Re: MCB Camp Lejeune May 28 Meeting

Enclosed please find minutes of the May 28, 1997 meeting at the NC DEHNR Wilmington Regional offices. The topics of this meeting were the Feasibility Studies for OU 6; and the proposal of Natural Attenuation for groundwater remediation for Sites 36, 54 & 86.

Meeting Minutes, May 28, 1997
OU6 Draft FS Meeting
MCB, Camp Lejeune, North Carolina

SITE 54
 RAA 3: NATURAL ATTENUATION WITH OPERATIONAL CONTROLS
 GROUNDWATER MONITORING PROGRAM
 SITE 54, CRASH CREW FIRE TRAINING BURN PIT
 FEASIBILITY STUDY, CTO-0303
 MARINE CORPS AIR STATION, NEW RIVER
 NORTH CAROLINA

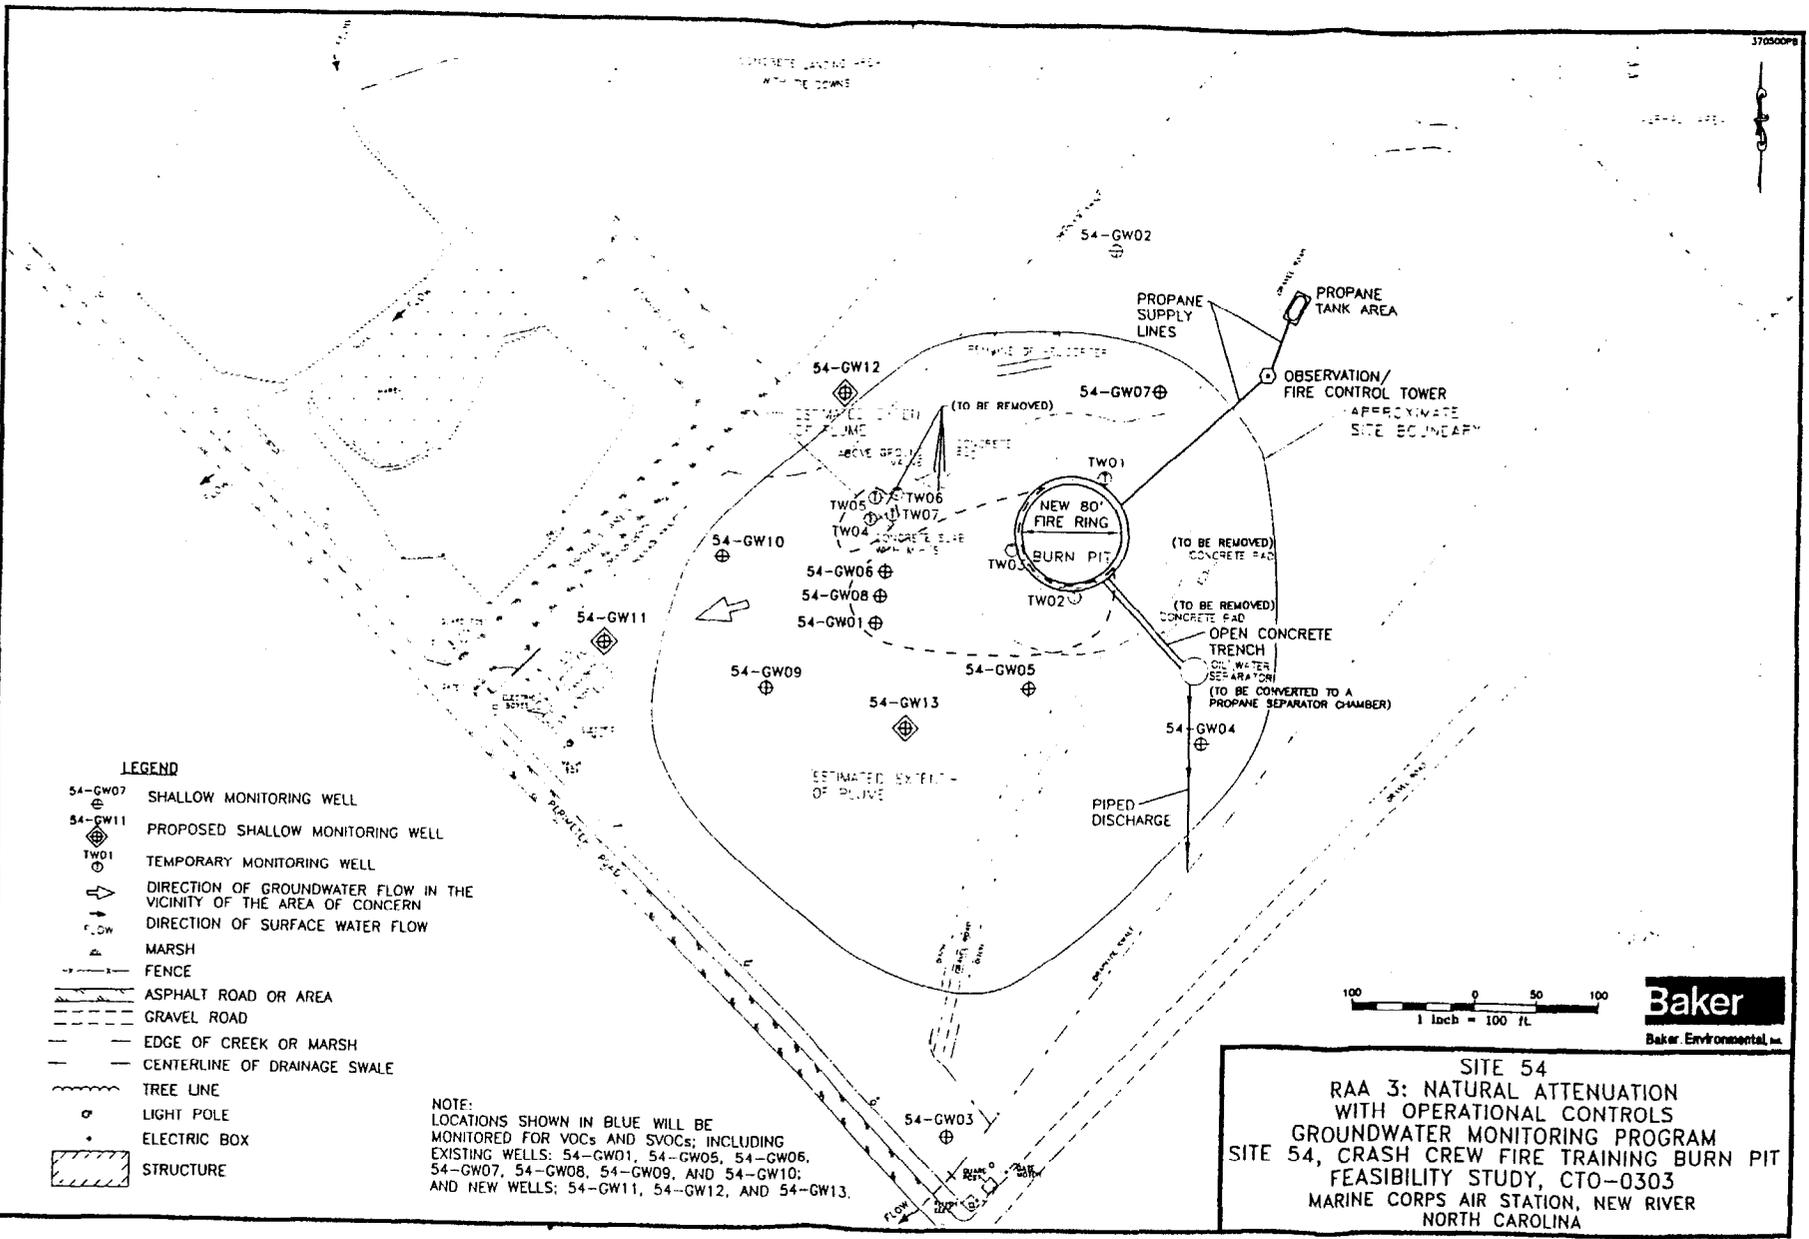
Mr. Stehman and Ms. Rossi were concerned that a gap in the sampling between existing wells 54-GW05 and 54-GW09. As discussed during the meeting, proposed well 54-GW12 identified under the Natural Attenuation Remedial Alternative (see handout Figure 54-13) will be shifted to the south to eliminate the gap in sampling. This shifted well is identified as well 54-GW13 on the attached Figure for Site 54. In addition, proposed well location 54-GW11 and a post-meeting proposed well location, 54-GW12 (see attached Figure for Site 54) will be located west of existing well 54-GW07.

SITE 86
 RAA No.3: NATURAL ATTENUATION
 SITE 86, TANK AREA AS-419-AS421 AT MCAS
 FEASIBILITY STUDY, CTO-0303
 MARINE CORPS AIR STATION, NEW RIVER
 CAMP LEJEUNE

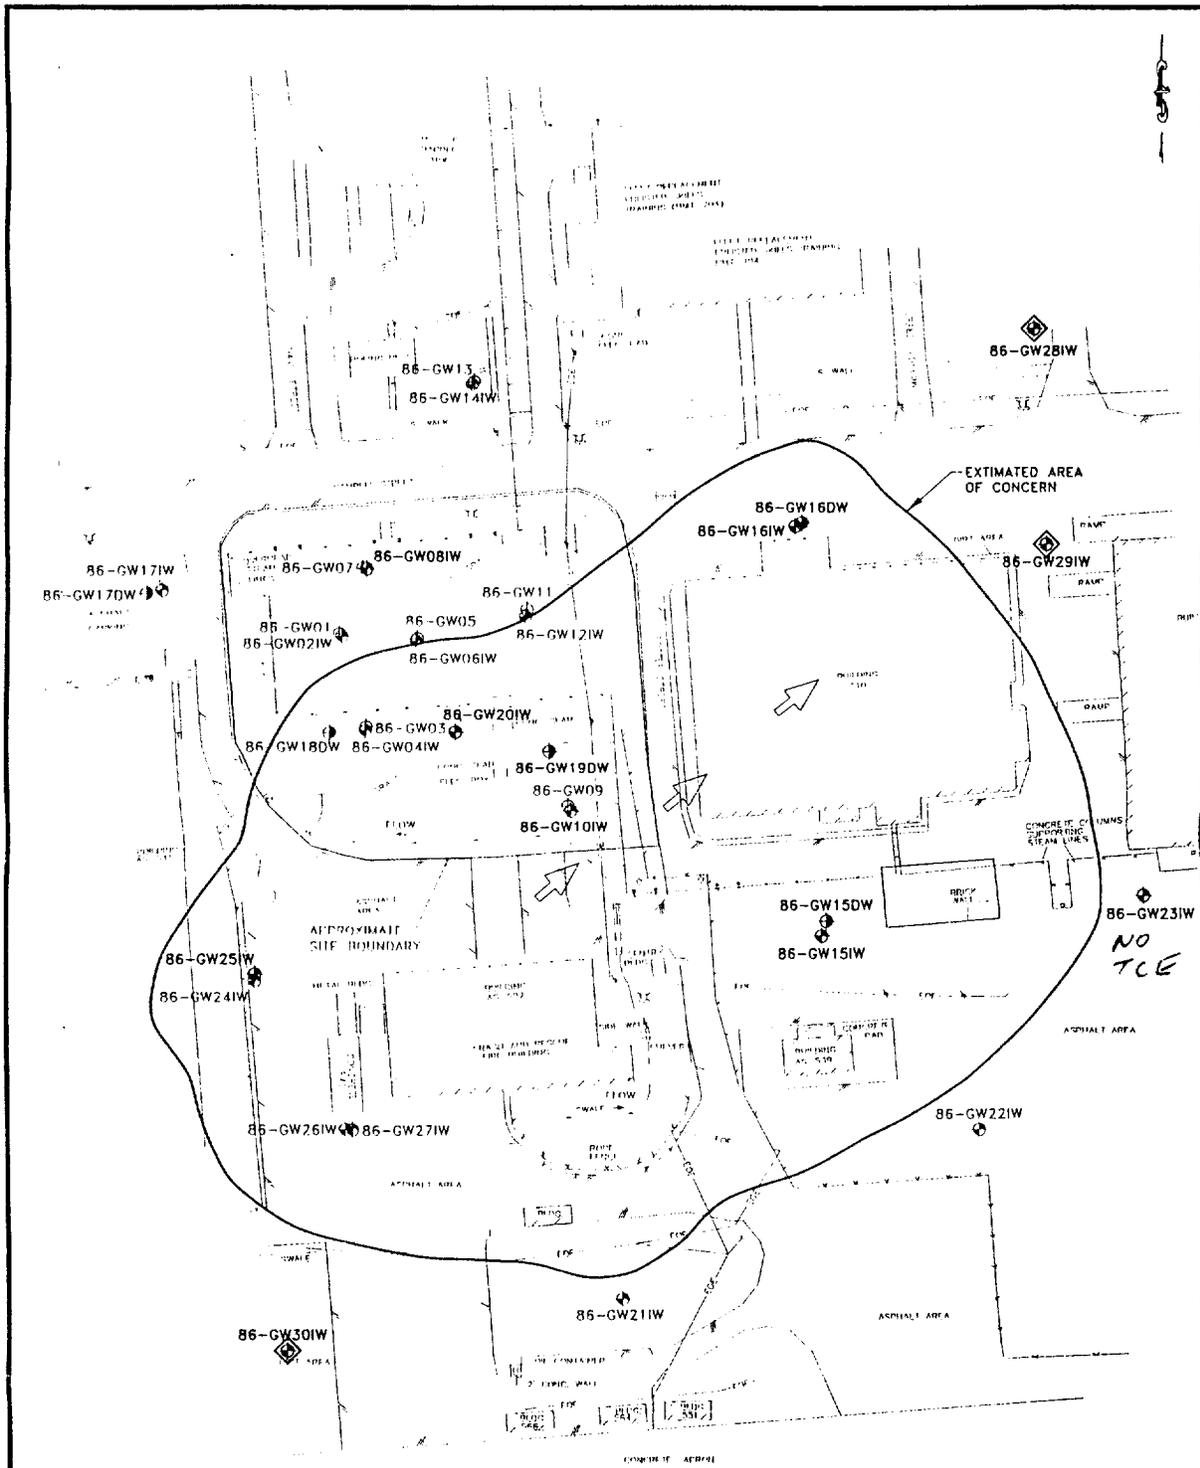
Mr. Stehman and Ms. Rossi voiced concerns regarding the possibility of additional sources, as well as, the potential for migration of the volatile area of concern. Baker reviewed a plan view of the volatile detections and the affected cross section, Site 86 handout Figures 86-7 and 86-3. Baker discussed the proposed placement of additional wells as presented on Site 86 handout Figure 86-18. In addition to the proposed location of well 86-GW28IW, two additional well locations were discussed (one located north of existing well 86-GW23IW and south of proposed well 86-GW28IW, and the other new well would be located south of existing wells 86-GW26IW and 86-GW27IW).

Action Item: Baker will install the additional wells as described above and as shown on the attached Figure for Site 86. These new wells will be included within the monitoring program under the natural attenuation remedial actions.
